Petition Number: 2023-046

From: Jake Carpenter, PE Reviewer: Natalie King, PE

Date	Description	
08-25-23	First Review (NK)	
09-20-23	Second Review (NK)

Transportation Summary

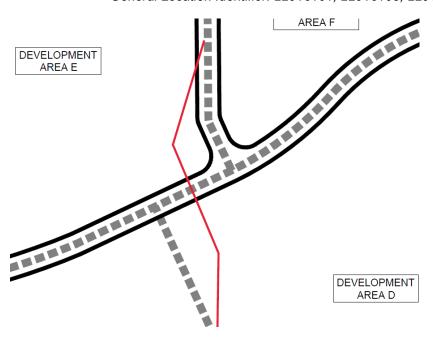
7. Outstanding Issue 8/24/23: Remove this intersection, and ensure all future horizontal curves meet the minimum CDOT standard of 150' radius.
